DRAINAGE AND TRANSPORTATION INFORMATION SHEET

Project Title: Blvd 2500 **Building Permit #** _____ **Hydrology File #** _____
DRB# PR-2018-00158 **EPC#** _____
Legal Description: TRS 1 2 & 3 Unit 1 Together w/TRS 4 5 & 6A Unit 2 Dale J Bellamahs Carlisle Replat & Lot 22A Plat of Lt 22A City Address OR Parcel 2500 & 2412 Carlisle Blvd NE
Blk 22 Timoteo Chavez Addition & Port of BLKS N & O Timoteo Chavez Addition

**RE: RESPONSE TO CONCEPTUAL TRAFFIC CIRCULATION LAYOUT COMMENTS
BLVD 2500
NE CORNER OF CARLISLE BLVD & CUTLER AVE**

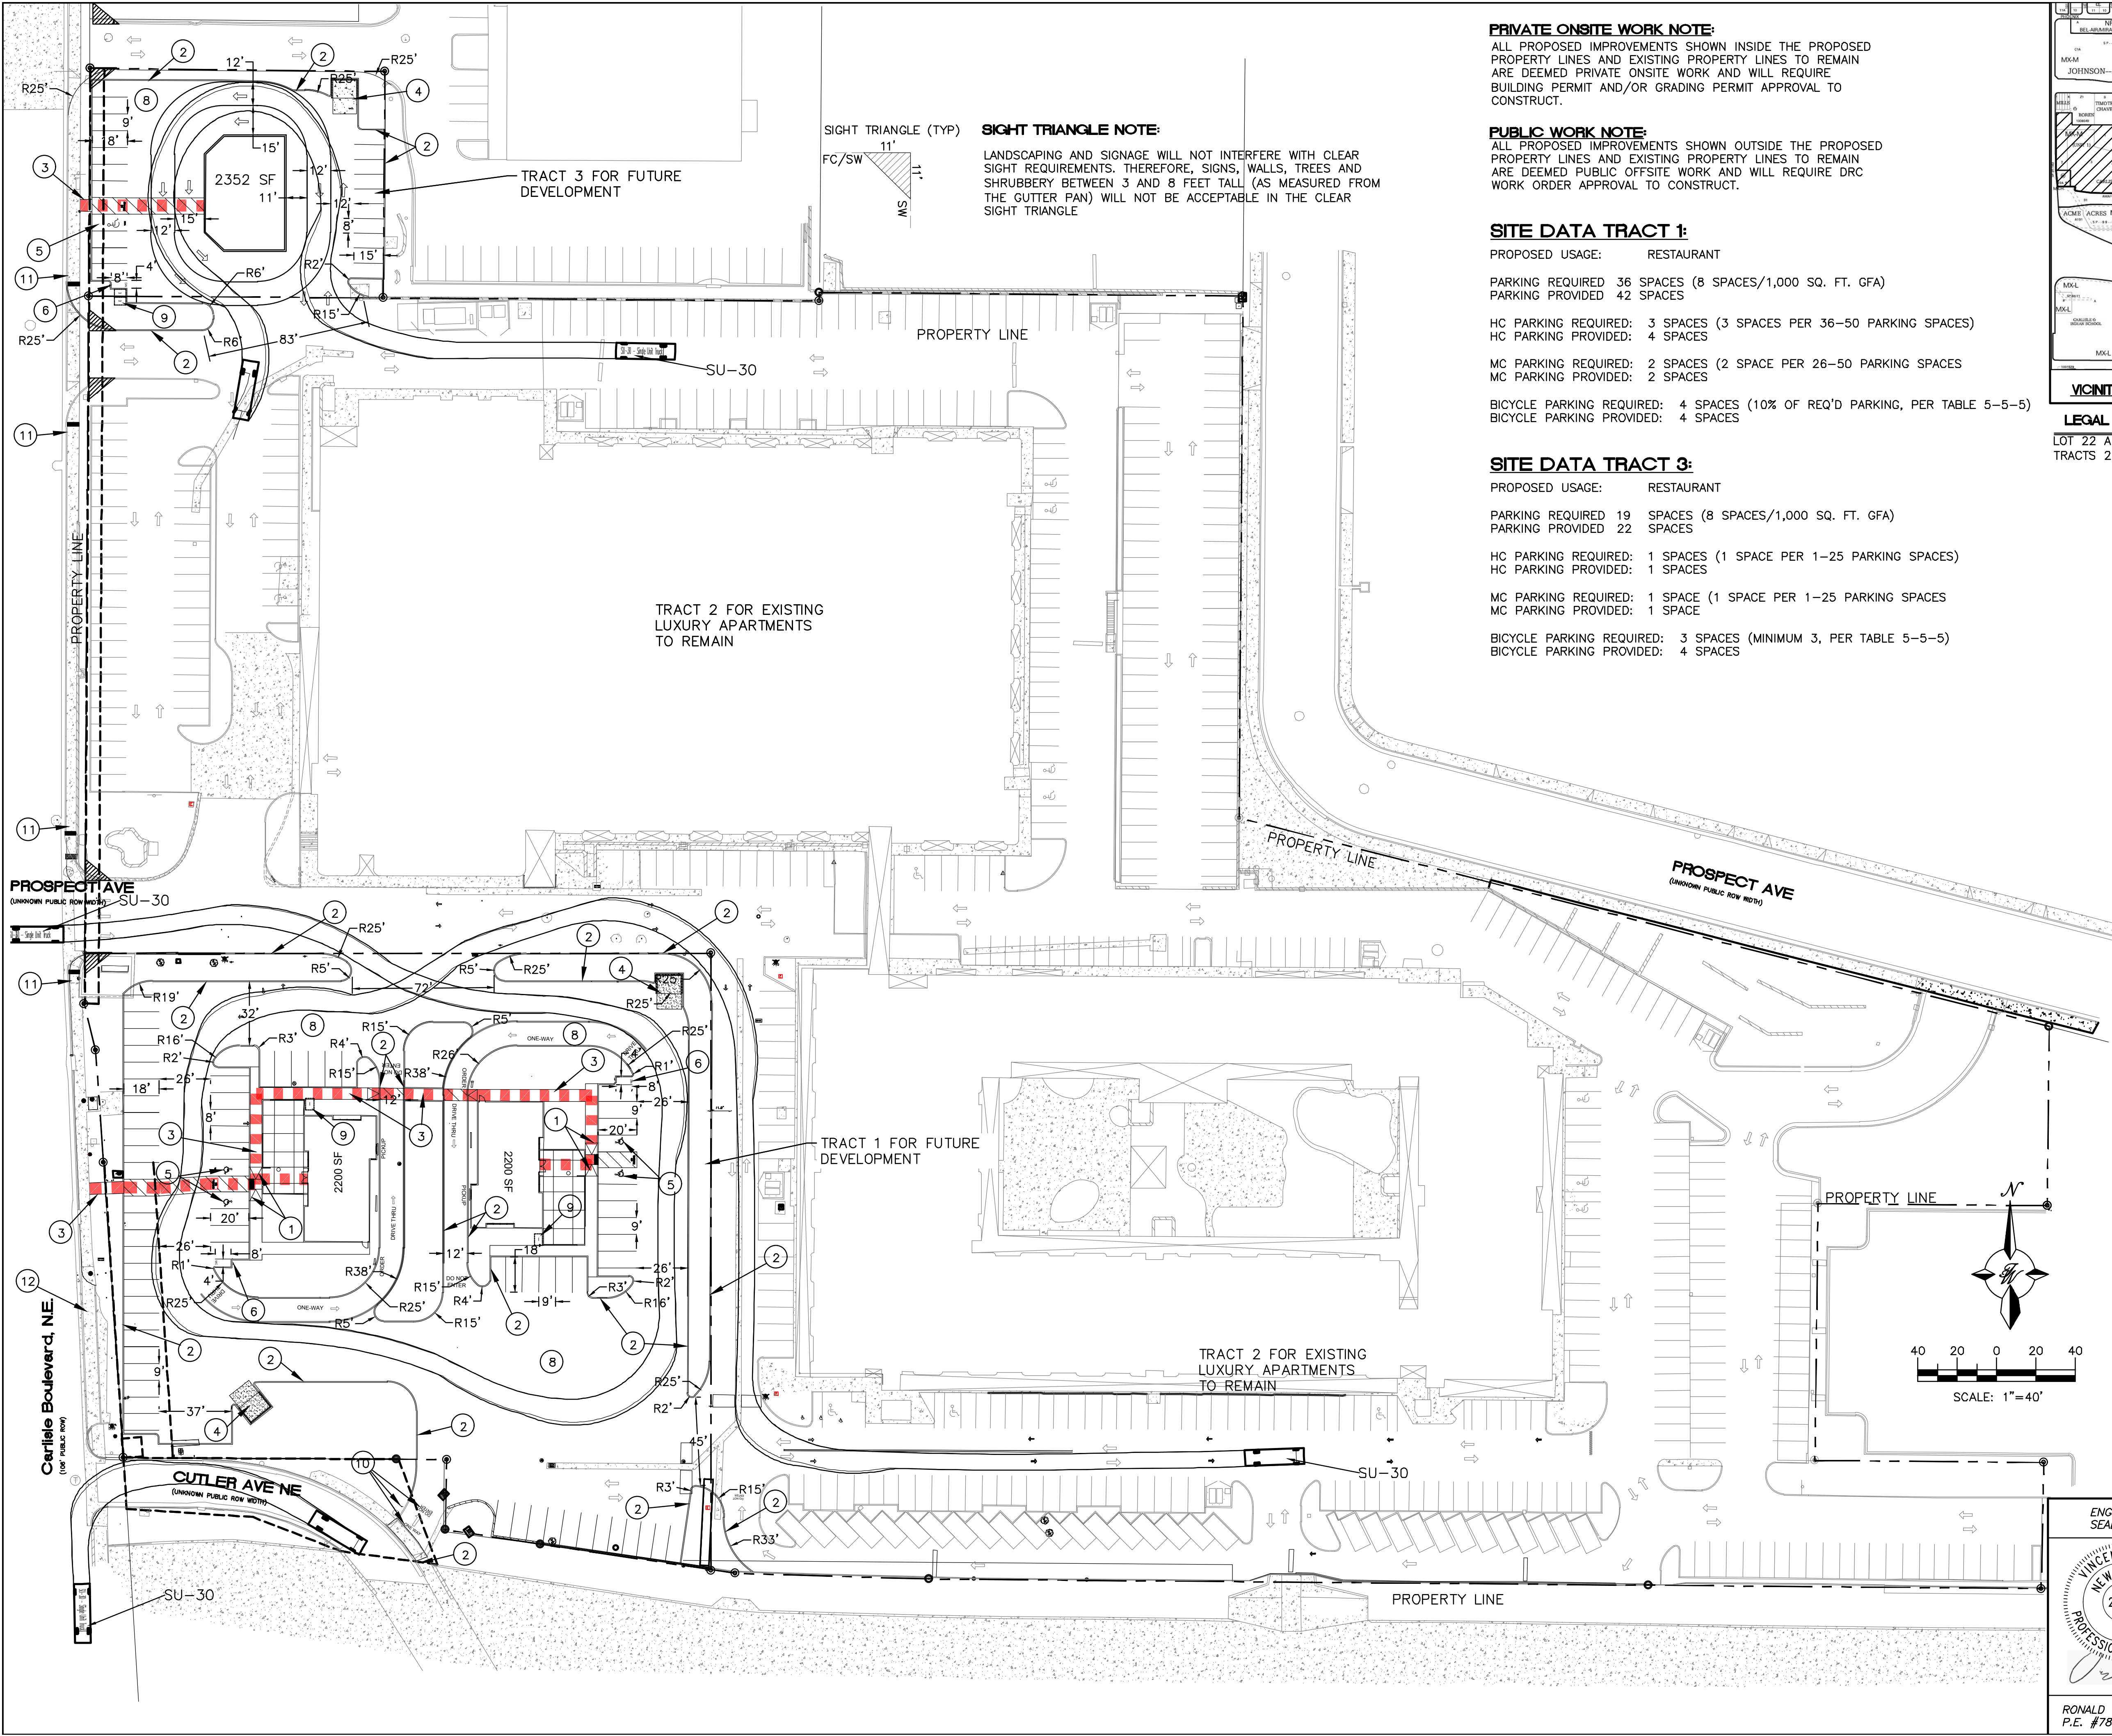
1. List the number of bicycle spaces required by the IDO.
RESPONSE: Required and provide bicycle spaces are shown under the "Site Data". Bike racks have also been added and called out with keyed note 9.

2. Grades and slopes in the parking area and/or the ADA Accessible parking areas appear to be too large. Please provide more detail.
RESPONSE: The proposed grading plan for the property was reviewed to show that all of these ADA parking areas do not exceed 2% in any direction. Keyed note 5 has been updated to stated 2% max slope in any direction.

4. Please clarify, is the site access off Cutler ONE Way? If so, please provide "ONE WAY" sign and pavement marking.
RESPONSE: The access off Cutler is one way. "ONE WAY" and "DO NO ENTER" sign and pavement markings are shown and called out as Keyed Note 10.

5. ADA Curb ramps for site accesses along Carlisle must be updated to current standard and have truncated domes installed.
RESPONSE: ADA unidirectional ramps w/ truncated domes are now shown along Carlisle to be removed and replaced and called out with Keyed Note 11.

7. Per the IDO, a 6 ft. wide ADA accessible pedestrian pathway is required from the public sidewalk to the building entrances. Please clearly show this pathway and provide details.

RESPONSE: A 6' wide pathway is highlighted in red to show ADA access from the public sidewalk to each building.
8. Per the IDO, a 6 ft. wide ADA accessible pedestrian pathway is required from the ADA parking stall access aisles to the building entrances. Please clearly show this pathway and provide details.

RESPONSE: A 6' wide pathway is highlighted in red to show ADA access from the Parking to each building.
9. It is not apparent what type of pavement surface is being proposed. A hard driving surface will be required as part of this proposed project for parking area and drive aisles.

RESPONSE: Keyed Note 8 calls for Private onsite asphalt pavement, with pavement section to follow Geotech report.
10. The proposed drive-thru lanes: all one way drives shall have "One Way" and "Do Not Enter" signage and pavement markings. Please show detail and location of posted signs and striping.

RESPONSE: "One Way" and "Do Not Enter" signage and pavement markings are shown on the plan for the drive-thru lanes.
11. Show the intersection clear sight triangle at the north side site access off Carlisle Blvd.

RESPONSE: Clear sight triangles are shown on all access points off of Carlisle Blvd.
12. Please specify the City Standard Drawing Number when applicable.

RESPONSE: A "Public Work Note" is on the plan stating that any work within public right-of-way will require DRC Work Order approval.
14. Unused curb cuts must be replaced with sidewalk and curb & gutter. A build note must be provided referring to the appropriate City Standard drawing.

RESPONSE: Keyed Note 12 calls for replacing existing driveway with curb, gutter, and sidewalk per COA Std Dwgs 2415A and 2430.
15. Add a note stating "All broken or cracked sidewalk must be replaced with sidewalk and curb & gutter." A build note must be provided referring to the appropriate City Standard drawing.

RESPONSE: A Sidewalk and Curb Note has been added providing this language.
16. Please provide a letter of response for all comments given.
RESPONSE: This letter acts as the response to comments given.

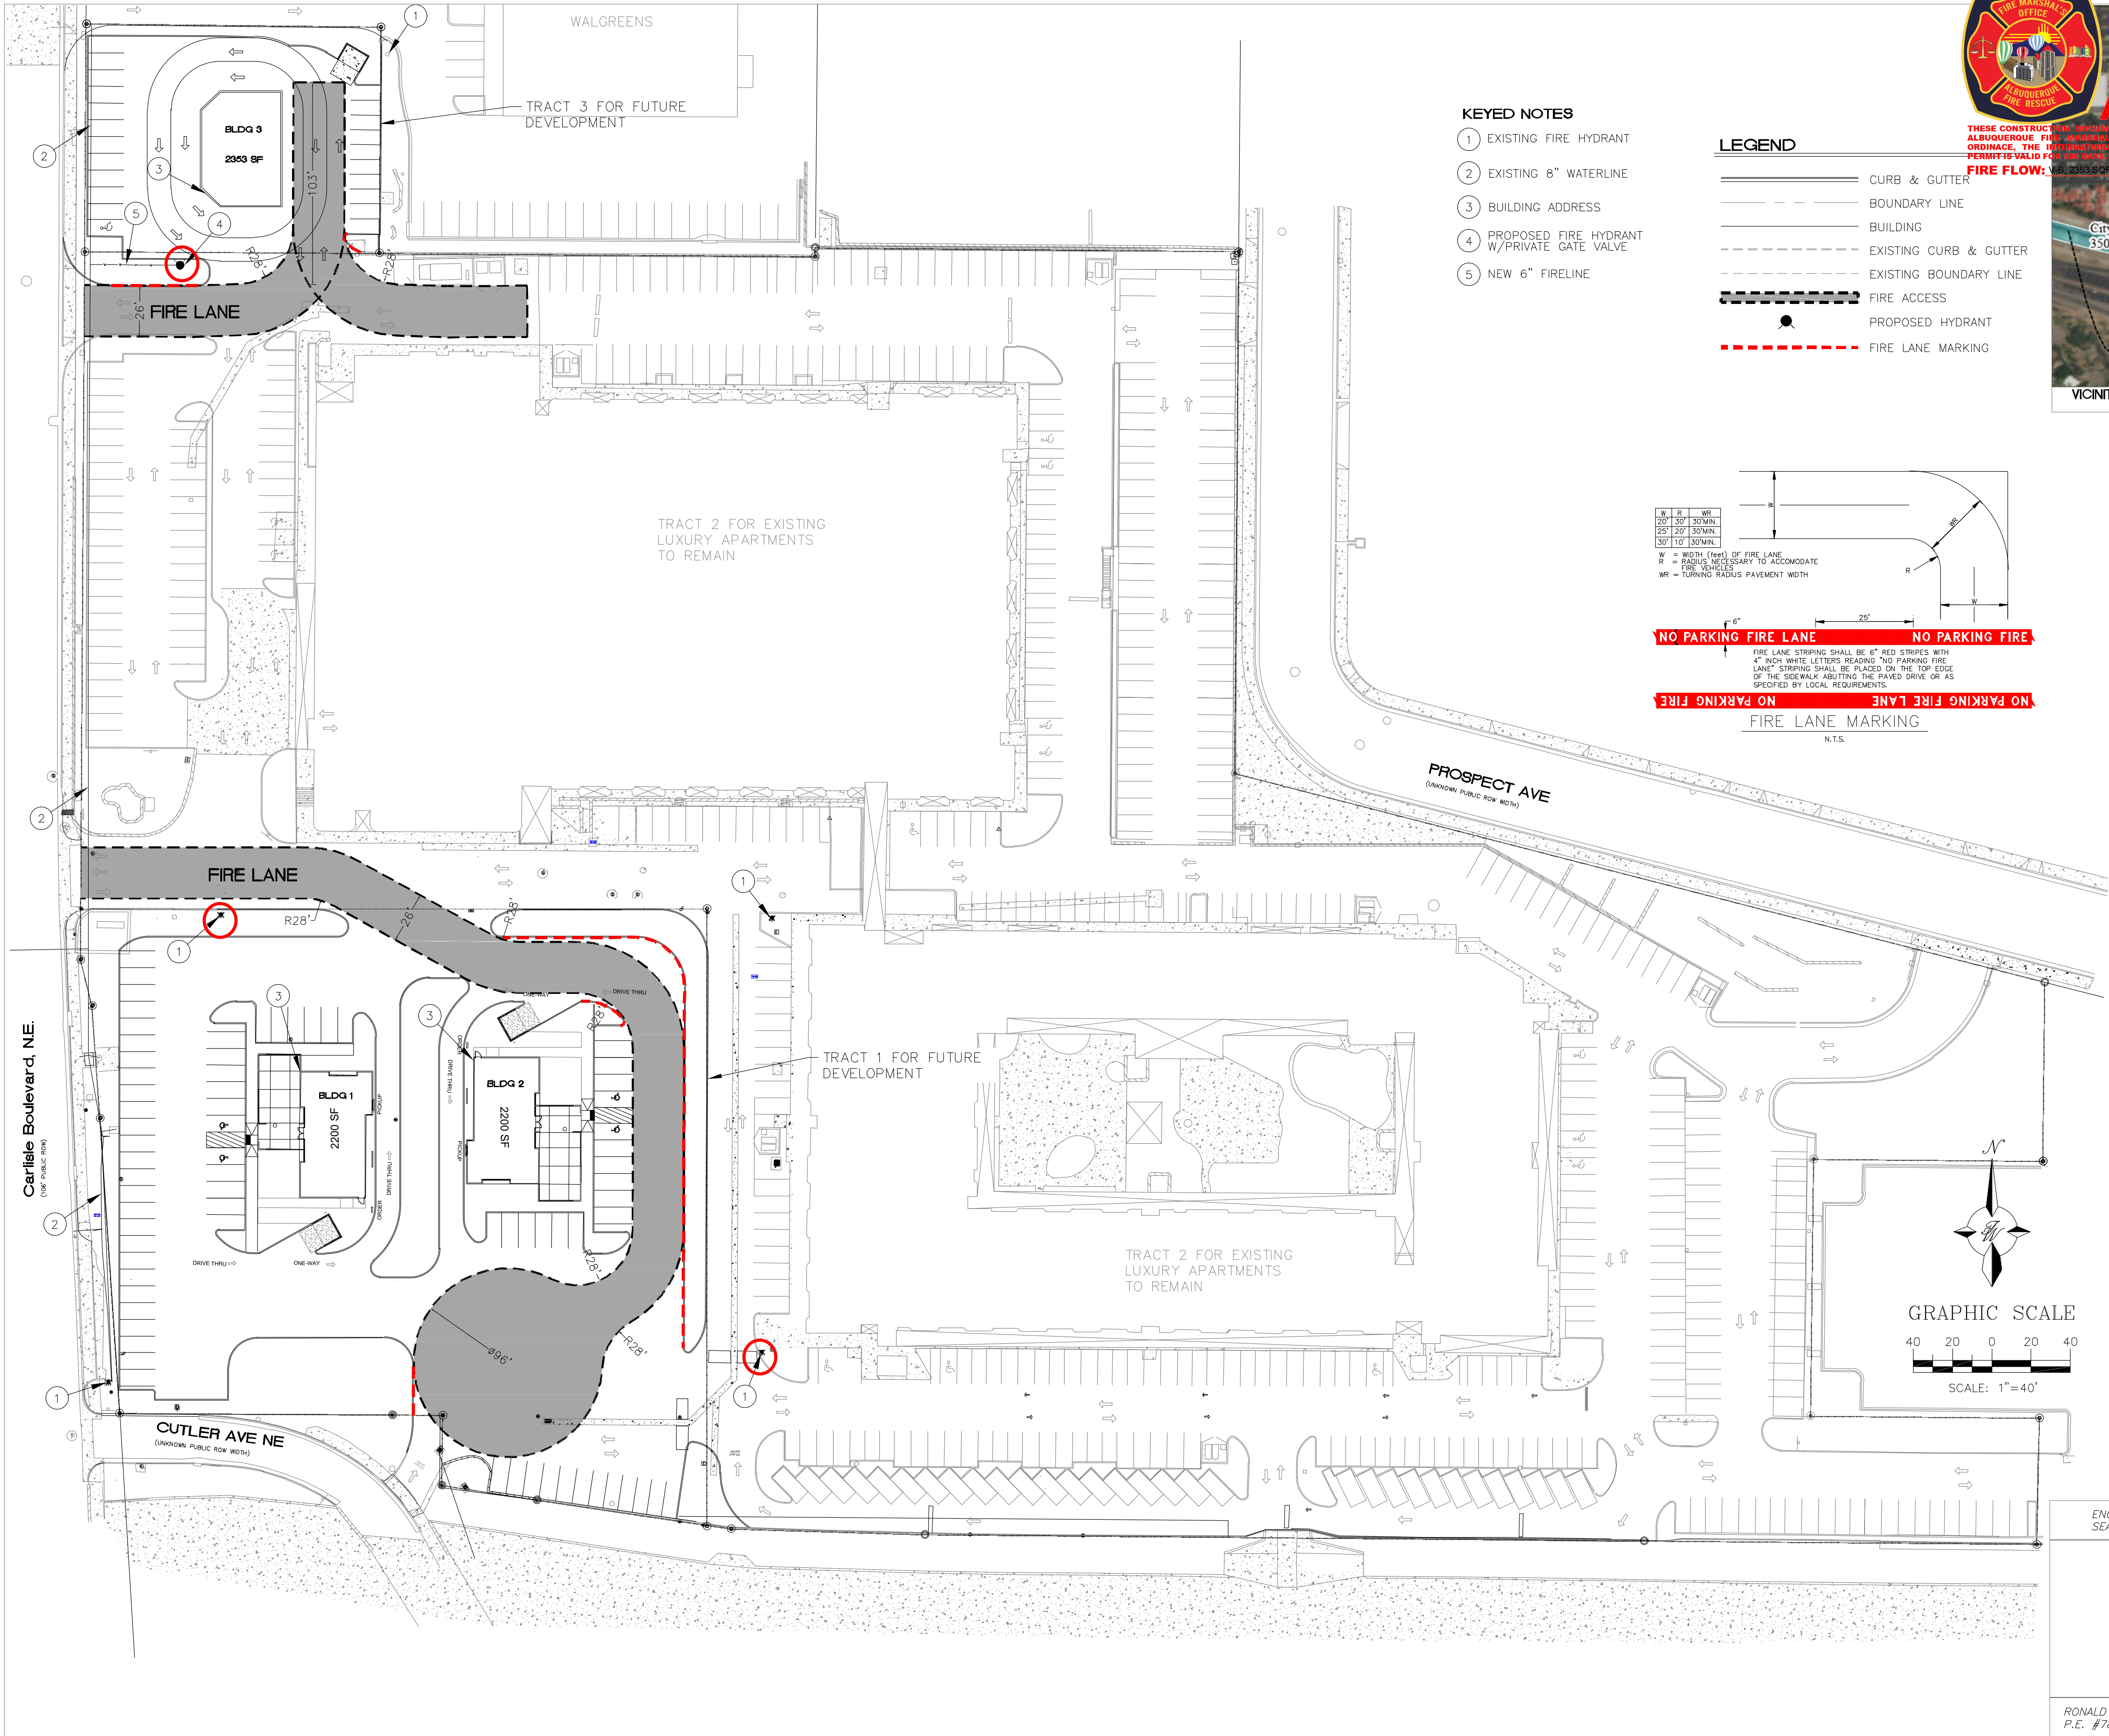
3. Provide Motorcycle parking space posted upright sign, either free standing or wall mounted per the zoning code.
RESPONSE: Keyed note 6 mentions motorcycle parking space w/ sign. A free standing sign detail can be found on Sheet C1.2.

6. Motorcycle parking spaces shall be designated by its own conspicuously posted upright sign, either free-standing or wall mounted per the zoning code.

RESPONSE: Keyed note 6 mentions motorcycle parking space w/ sign. A free standing sign detail can be found on Sheet C1.2.
